# AGENDA DESIGN REVIEW COMMITTEE

# DESIGN REVIEW COMMITTEE Astoria City Hall May 3, 2018

DR17-03

Design Review DR17-03 by Garry Vallaster, Astor Venture, LLC to construct an approximately 11,850 square foot commercial building at 2350 Marine Drive (Map T8N-R9W Section 9CB; portion of Tax Lot 6803; portion of Block 144, Shively's) within the Gateway and Civic Greenway Overlay Zone in the LS (Local Services) zone.

SITE PLAN - OPTION B

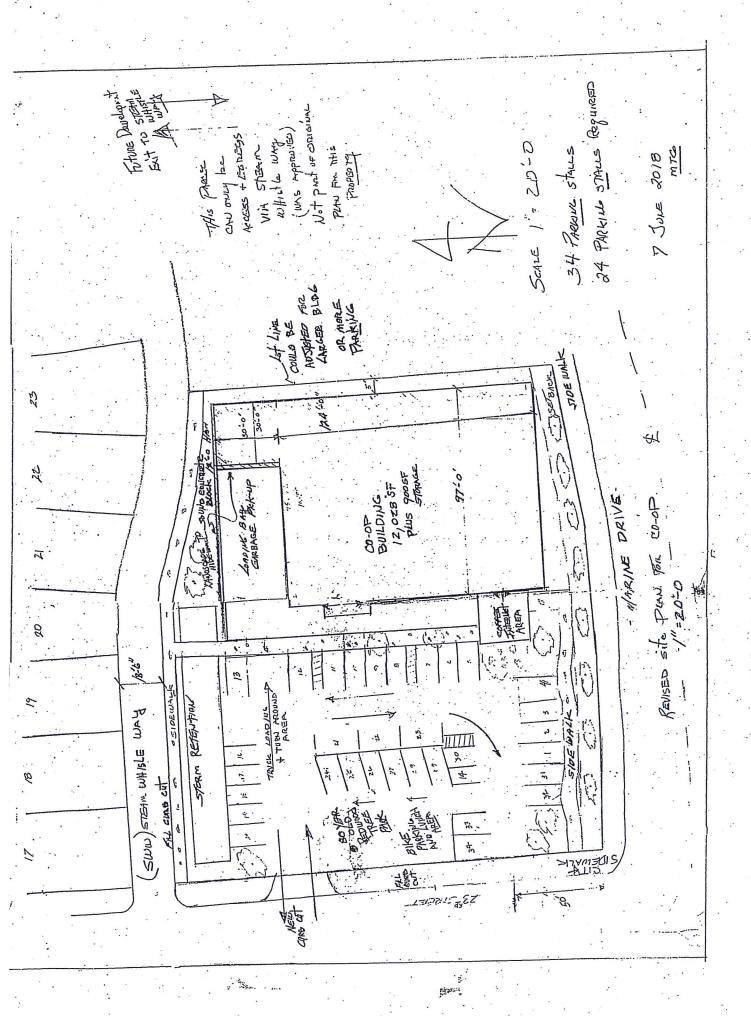
Lastly, we noted the City Review committee as well as our HOA and Mill Pond residents have struggled with the primary access off of Steam Whistle Way. We believe it would serve you well as well as your client to move forward with the plans you provided in option B with and access off of 23rd St.

In summary, we continue to support Developer's original Option B, which uses 23<sup>rd</sup> Avenue to access the Co-Op parking lot. The Option B plan is pedestrian friendly and visually consistent with the original vision of Mill Pond Village.

WEST ELEVATION

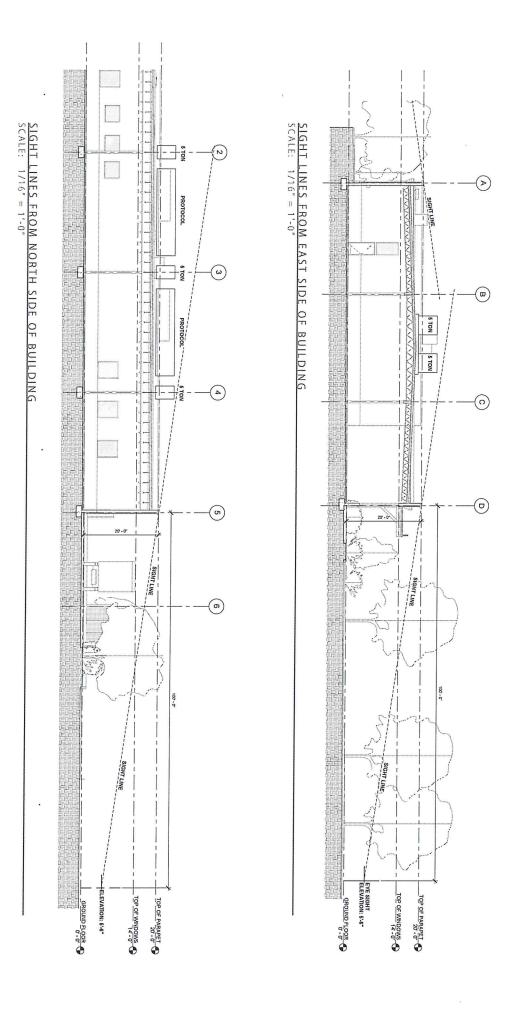
Commissioner Phelps said she liked the parking lot and wanted some of those design features to wrap around to the other side. She realized this would interfere with the floor plan, but the proposal was a very unappealing wall on 23<sup>rd</sup> Street.

The west side of the building is relatively long at 128' and as a further complication encloses a number of essential back of house working areas of the Store making it difficult to fully fenestrate that wall. However we have added more windows and raised the window head heights to 12' to allow passing pedestrians an almost full view of internal store activities. Adding windows of different sizes will increase architectural detail and provide more variety to the wall. To further activate the wall we will add a 6" metal shroud around six of the smaller windows that permit views into the work areas. The taller windows will be flush with the wall and will be located in meeting & office areas only.

- 1. With the addition of more windows we have still found ourselves with a blank wall area adjacent to bathrooms and a walk-in cooler on the inside of the building. To mitigate that blank area we are proposing to install a S.S. cable system along the wall that will support an espalier of (3) different types of fruit trees that will be active and changing through the growing season from spring blossoms through to the fall harvest. The preliminary thought is to provide a red and a green apple tree flanking a pear tree in the center of the installation.
